Autoblend System on Force Outboards

a - Spring P/N 686300
b - Retainer P/N 686096
c - Diaphragm

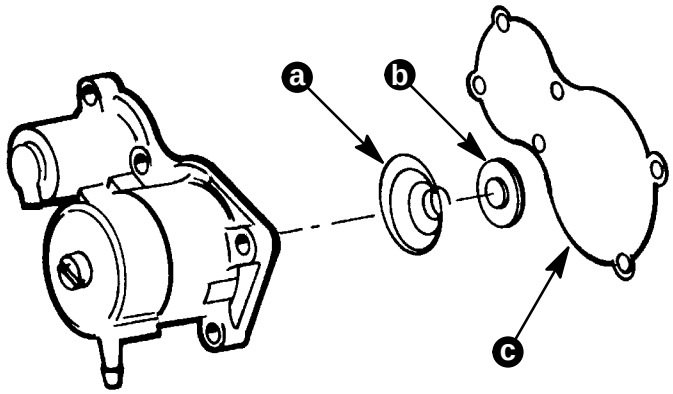
The Autoblend System can also be installed on any Force Outboard 35 HP thru 125 HP if the booster spring and retainer is installed in the fuel pump.

NOTE: It is always good practice to replace the fuel pump gasket and diaphragm when installing the booster spring and retainer in older engines.

F686300	Booster Spring
F686096	Retainer
